December 11, 2023

ADDENDUM #2
NWIT-23-19
SA-28 Pump Station Upgrades
New Westminister, BC

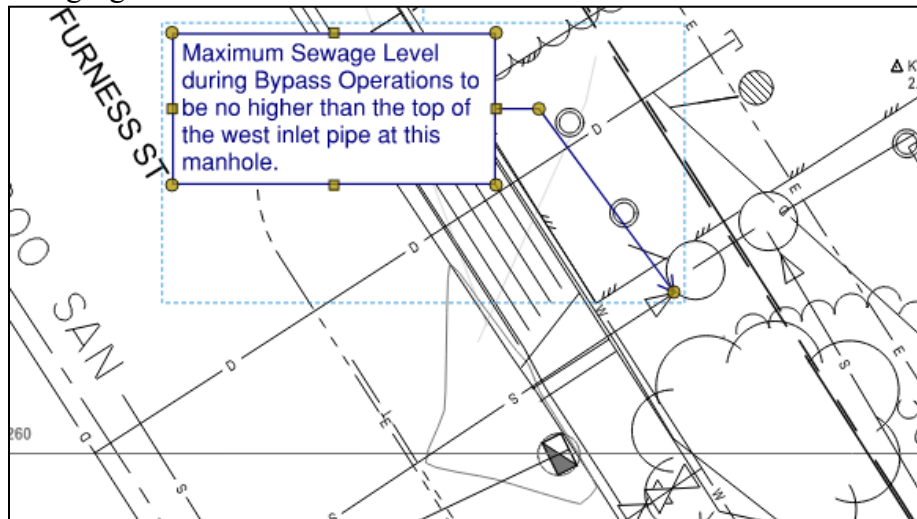
- 7) Section 01500 / Management and Disposal of Sewage During Upgrades / Bypass Operations is modified as follows:
 - a. An alternate maximum sewage level upstream of pump station is illustrated on the following figure:
